**To:** Development Permit Panel

**File:** DP 18-810720

**Re:** Application by Kasian Architecture Interior Design and Planning Ltd. for a  
Development Permit at 13171 and a Portion of 13251 Smallwood Place

LANDSCAPE PLAN

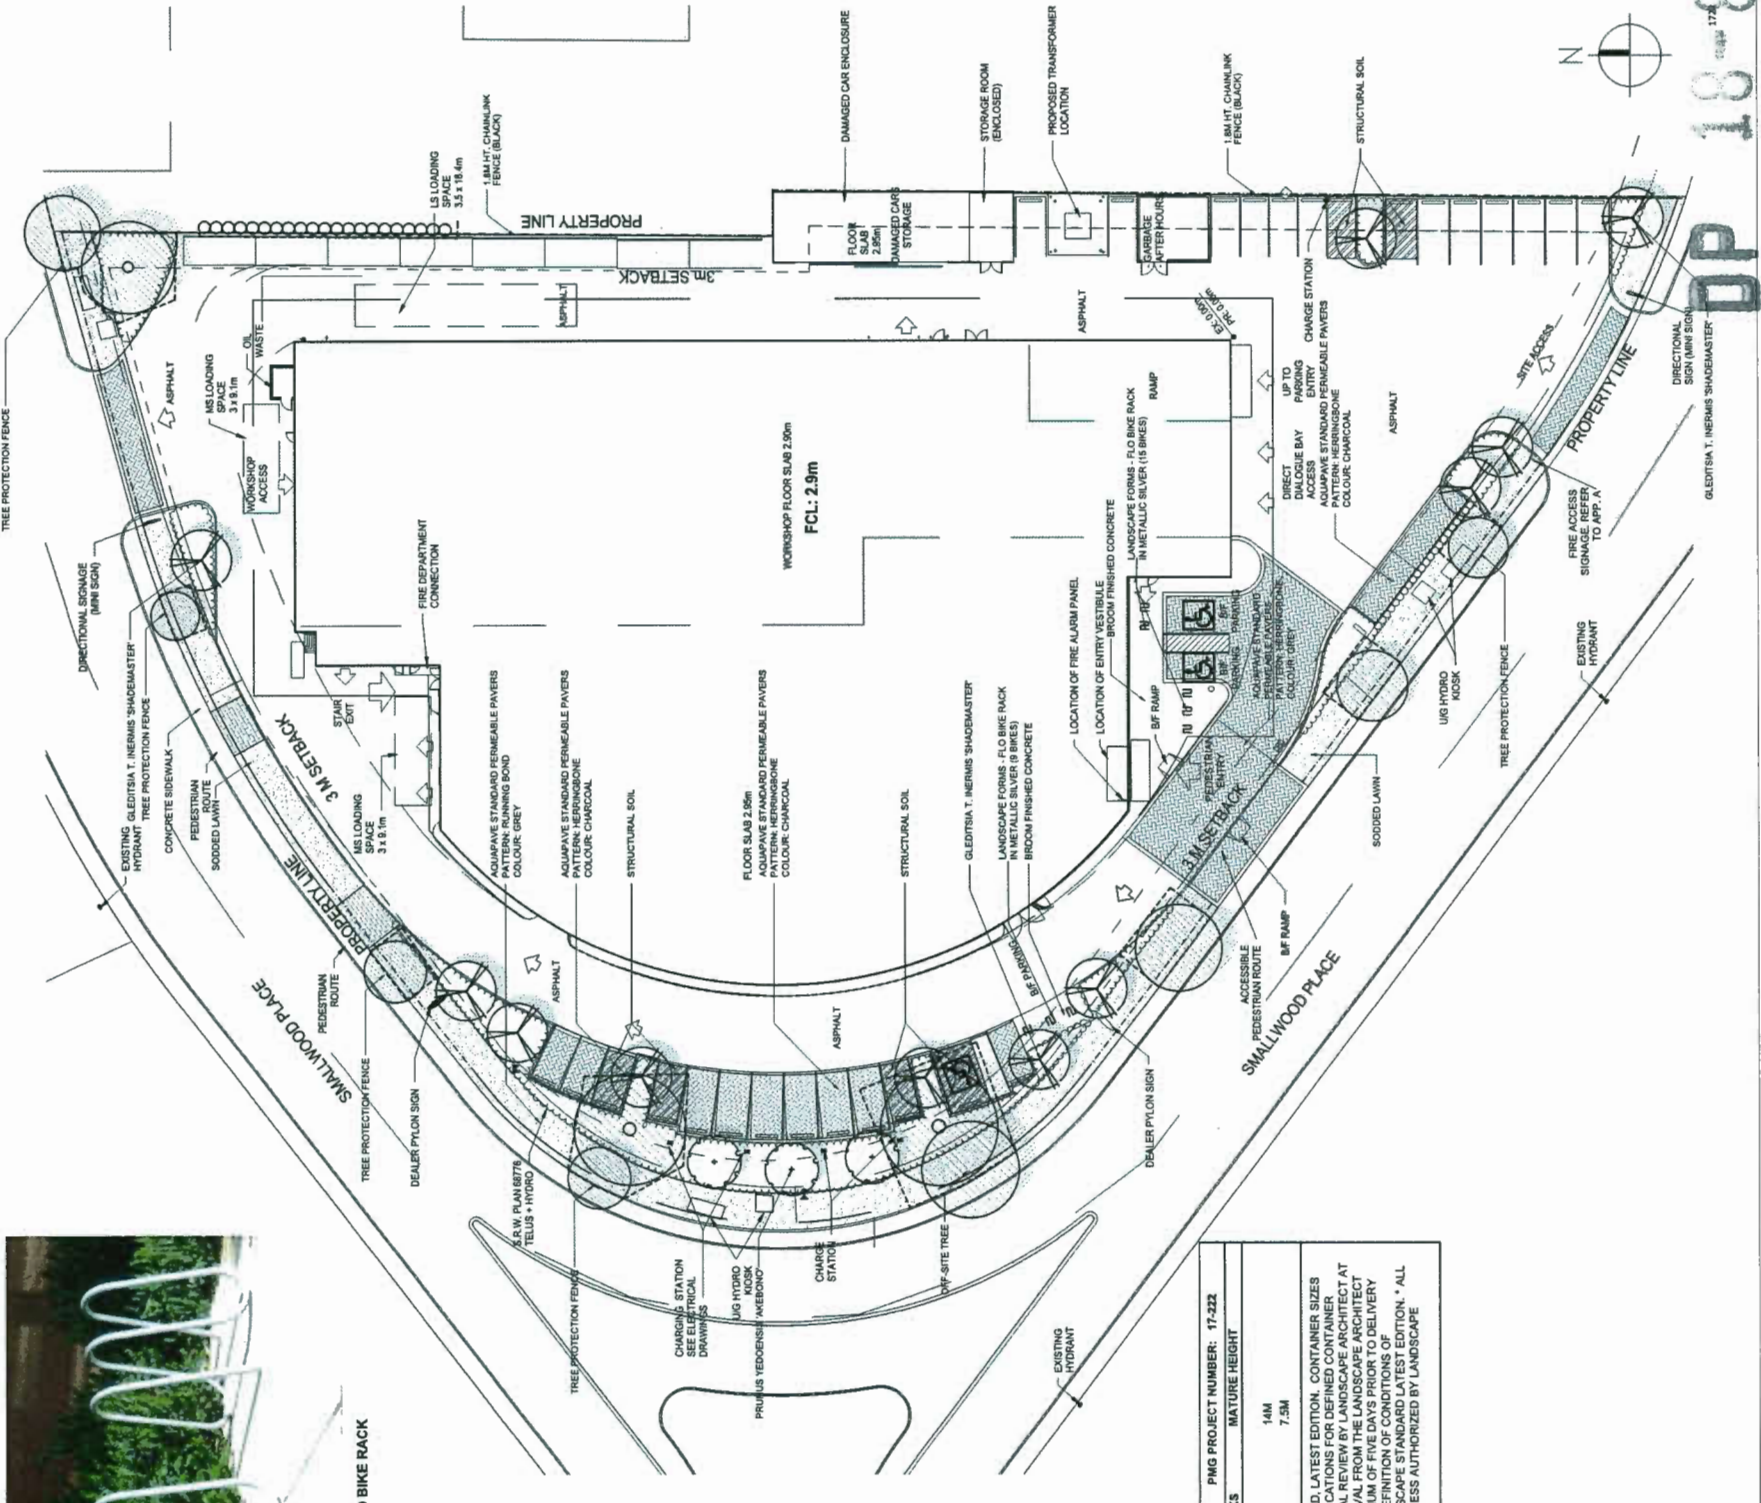
- proposed Gleditsia species replacement trees along the perimeter of the site are quite transparent, difficult to establish and are not visually appealing for the first ten years of planting; consider retaining the existing mature Gleditsia double row of trees, increasing the height and setback of the building, keeping the building form but bringing in the curved lines slightly, and relocating accesses to the site to increase tree retention;

- concerned on the two trees proposed to be planted directly in front of existing trees due to the tightness of the space and the potential of squeezing the canopies;

***KA Response: Gleditsia trees are required in the automall to meet design guidelines, so we are unable to respond to changing those. Similarly, we do not believe that there will be any support from the stakeholders (ORG, Porsche, RAMA, CofR) to decrease the building footprint and correspondingly increase the building height to accommodate these thoughts.***

**BUILDING ELEVATIONS**

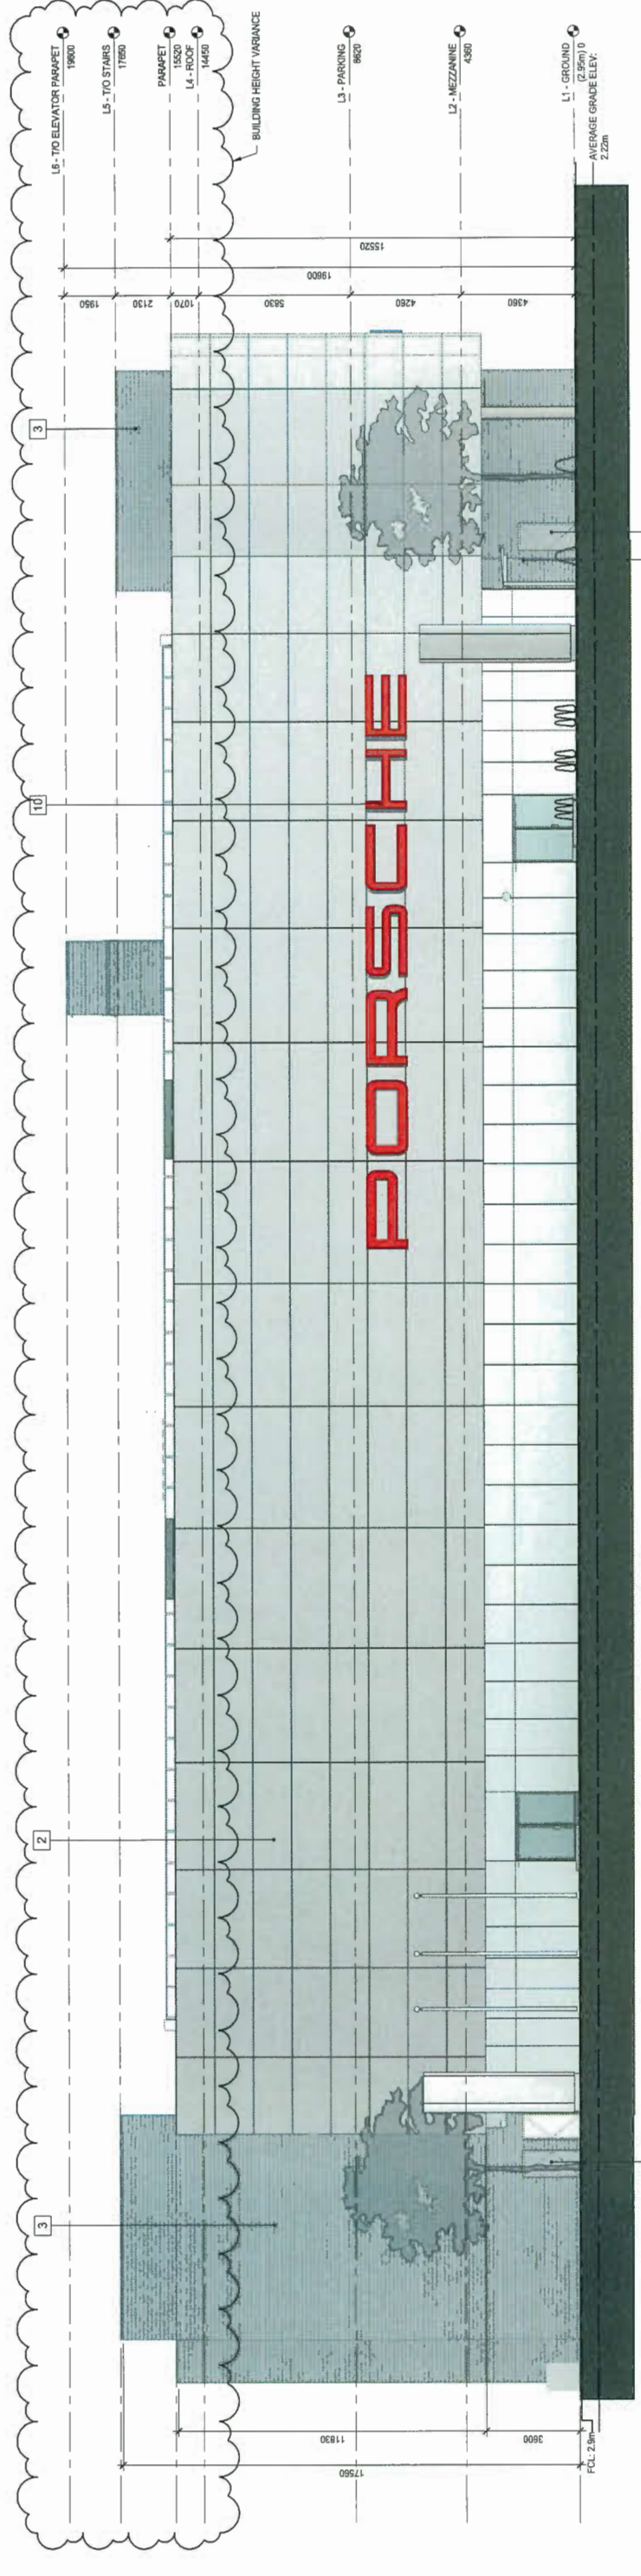
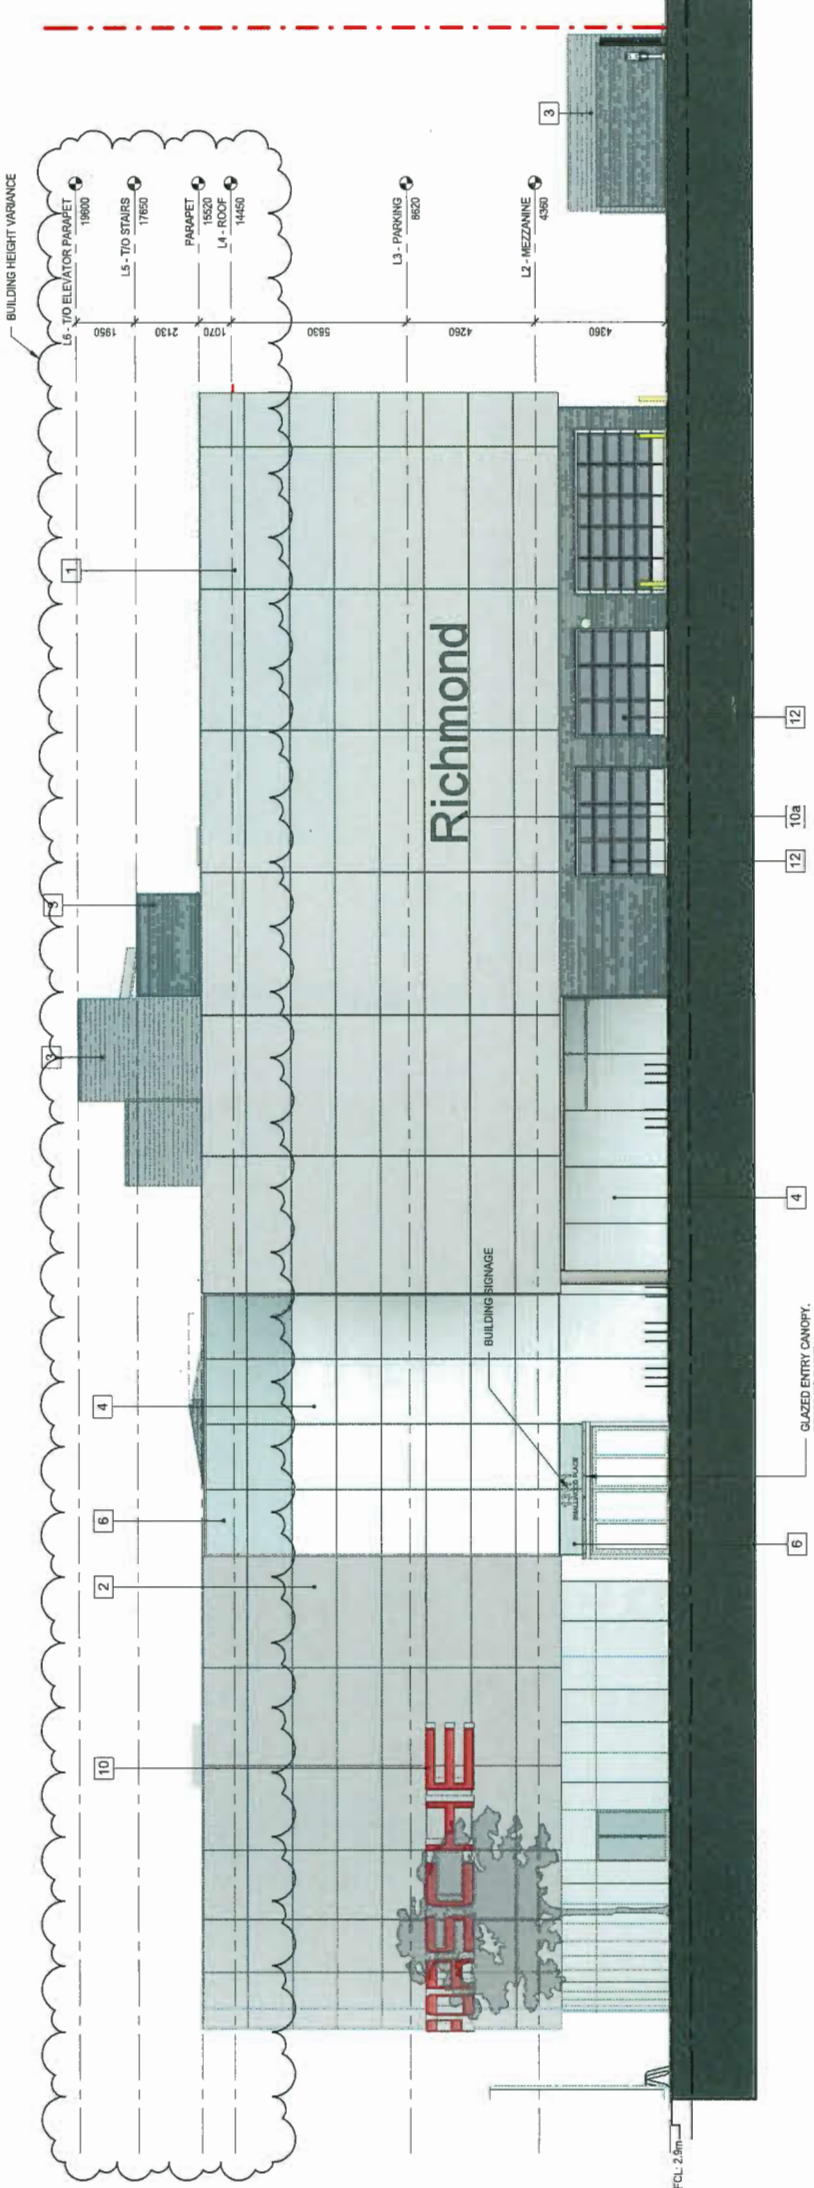
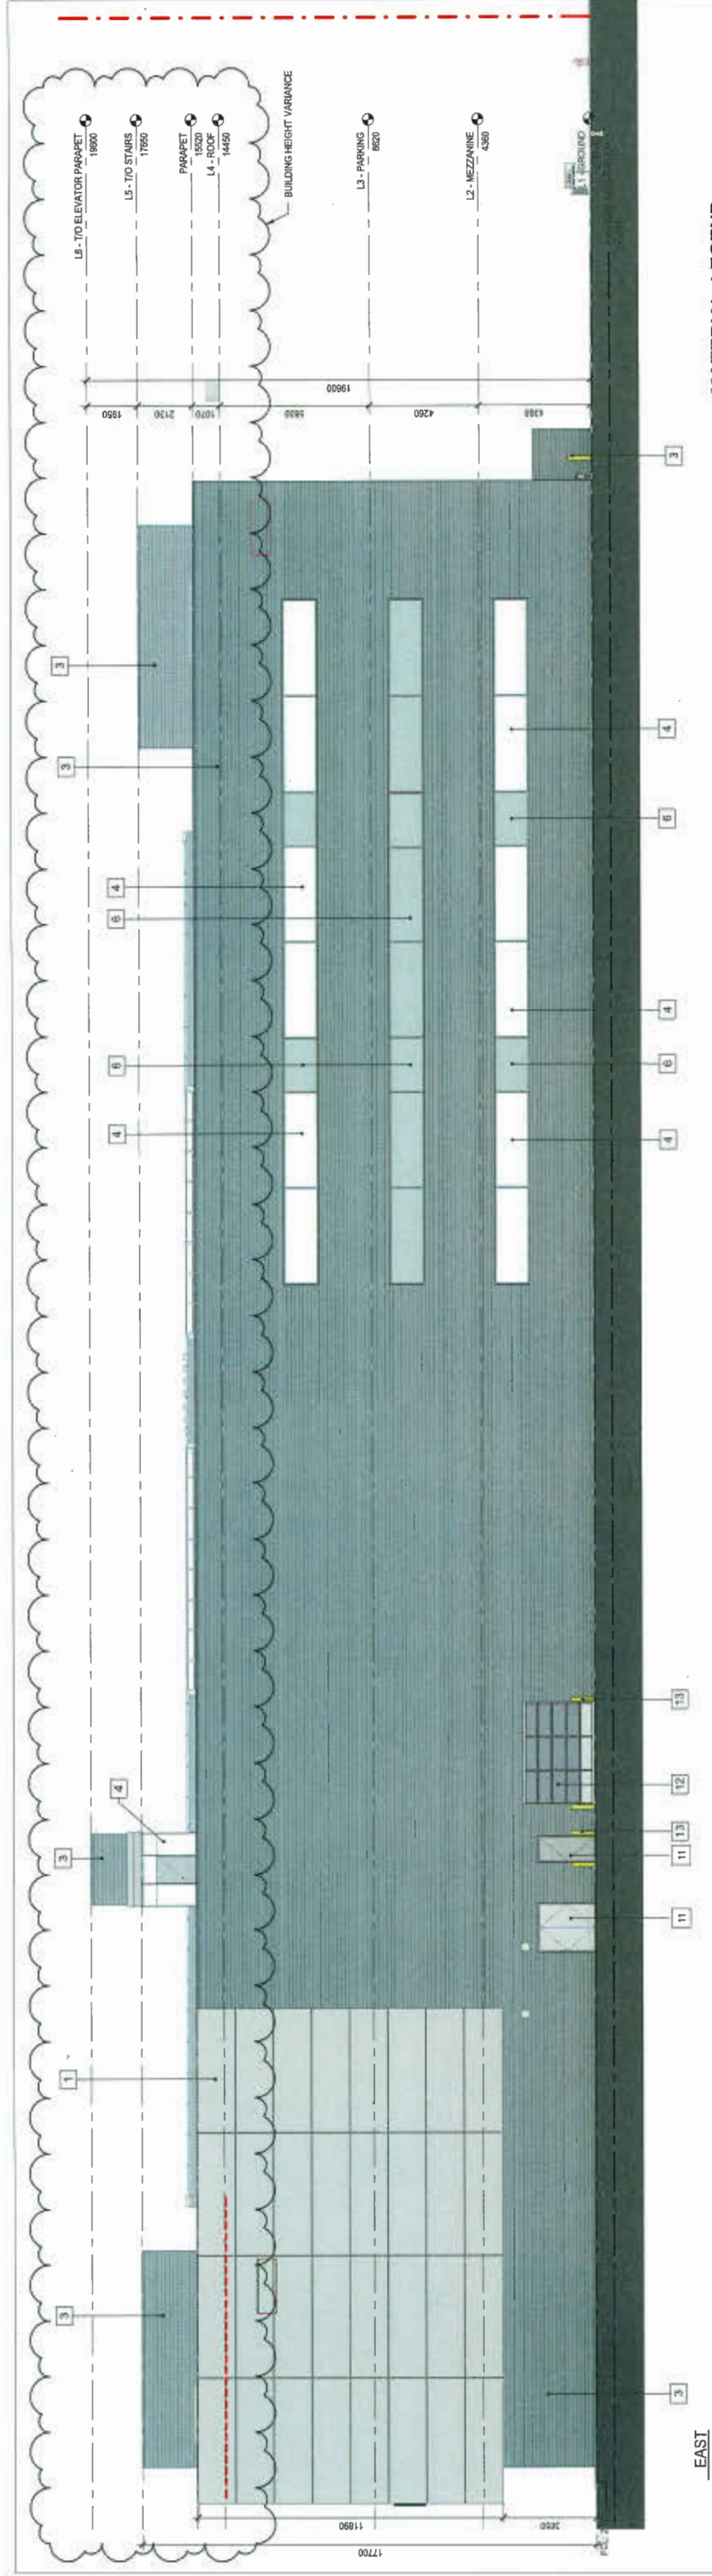
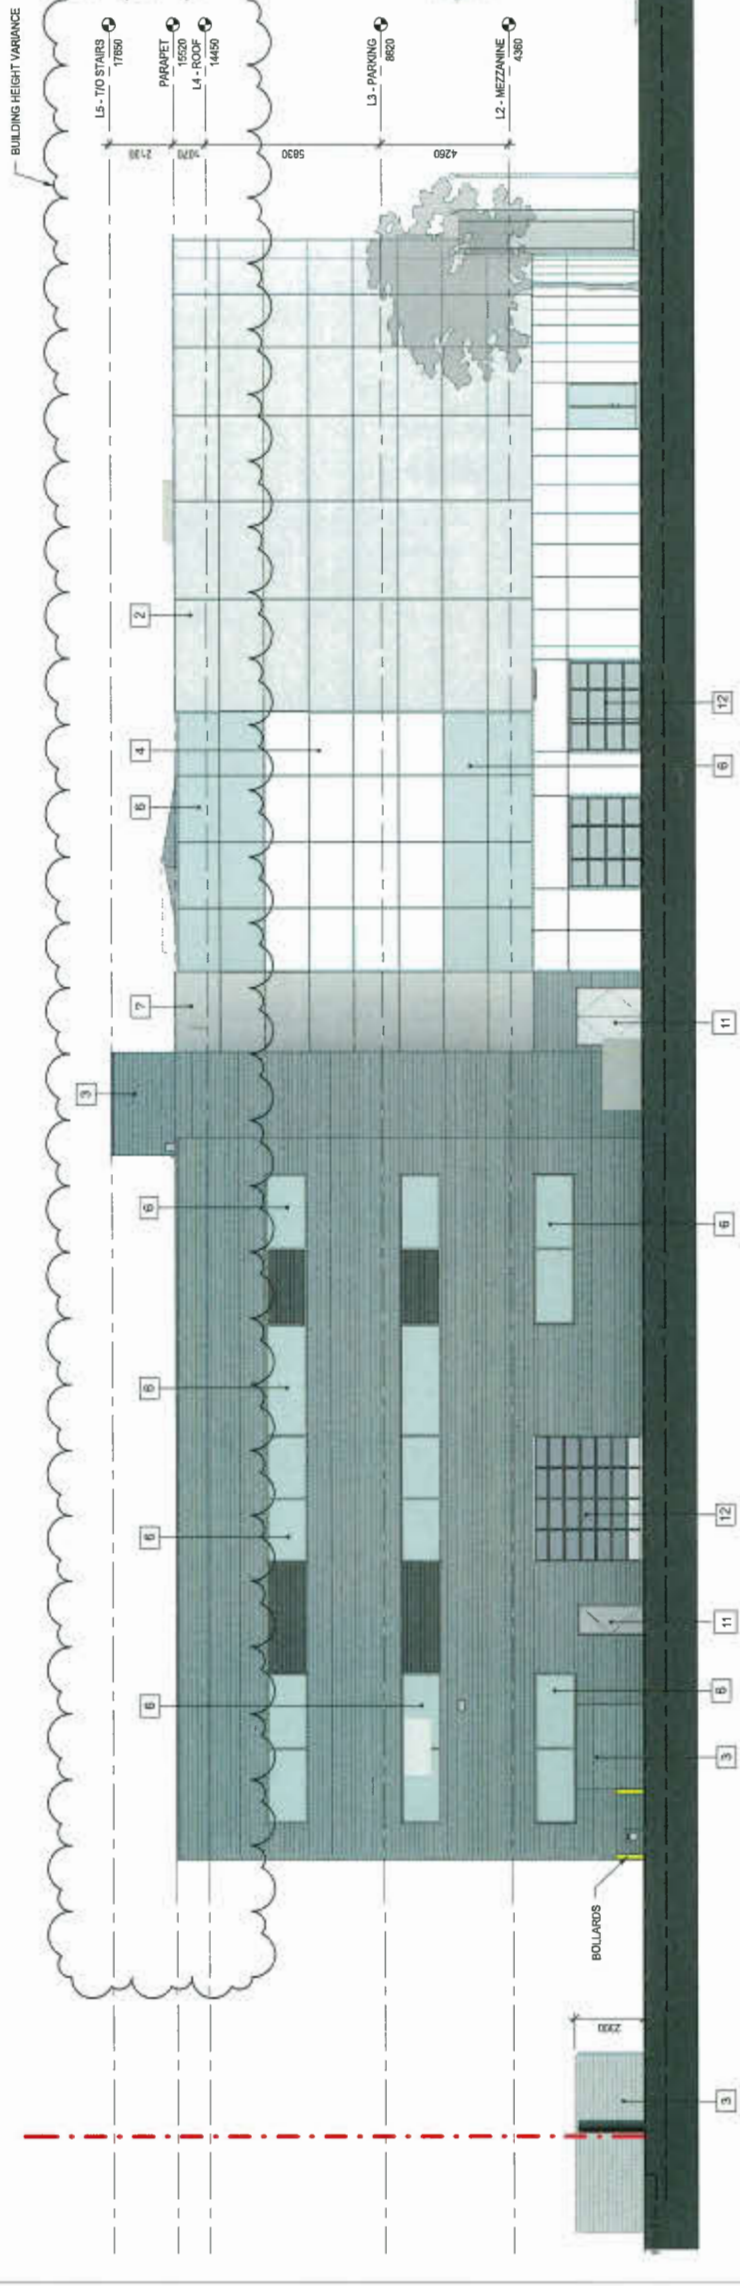
- consider installing canopies to provide weather protection considering the local weather; could be incorporated into the existing building design;

- the building's west façade is horizontally massive; consider installing vertical window strips and incorporating additional colours to the metal panels on the west façade to break down the massing, provide visual interest and create a pedestrian scale along the west façade;

***KA Response: This element of the exterior treatment was considered but not initially implemented as the exterior facades of the building have been designed in accordance with Porsche Design Guidelines, which do not include canopies. However, ORG has asked us to show a design solution that provides weather protection at the front entry.***

***KA Response: The west façade of the building has been designed in strict conformance to Porsche Design Guidelines and does not provide for additional colours/glazing.***

***KA Response: We have reviewed this item with ORG and Porsche and are proposing the addition of windows to the north façade. Refer to exterior elevations.***
